Technical Service Bulletin

**MODEL(S)
AFFECTED:****Tennant T7 Rider Scrubber**

Potential squeegee lift actuator and/or spring housing failure due to a clearance issue.

**Squeegee Arm Weldment Modification:**

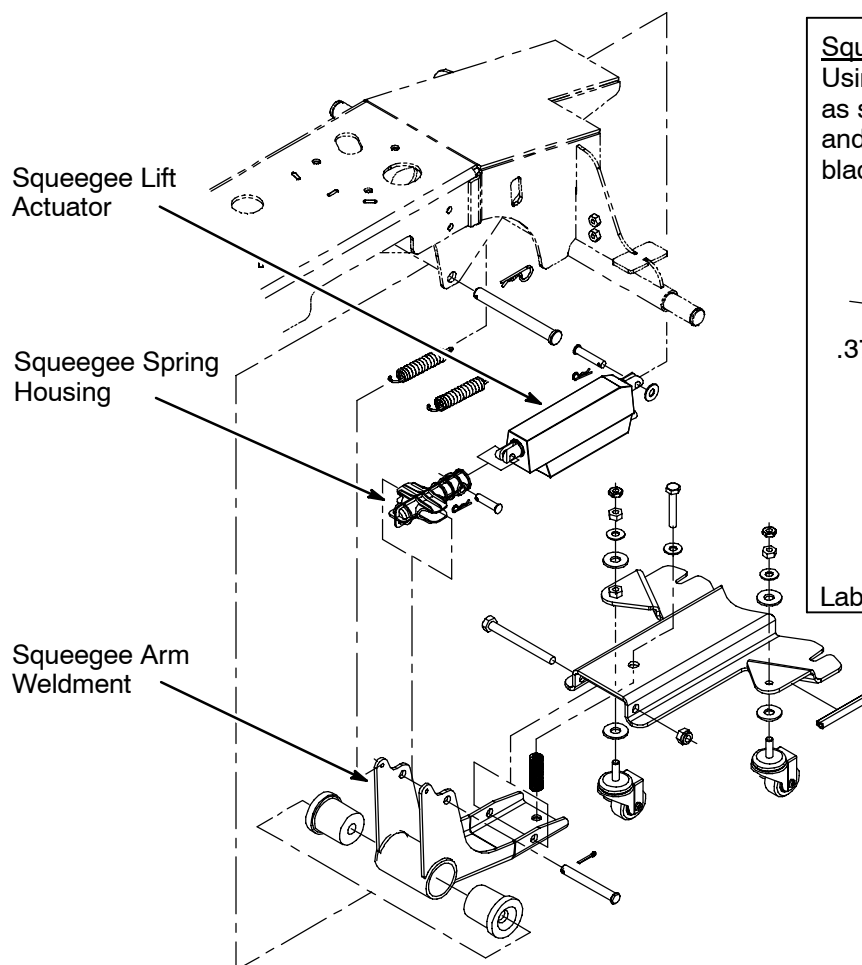
To prevent potential actuator and spring housing failure, the squeegee arm weldment must be modified as described below. The suggested modification will provide proper clearance for actuator movement, eliminating the risk for failure.

Using a die-grinder, remove the material as shown. Blow out the metal shavings and touch up the exposed metal with black paint.
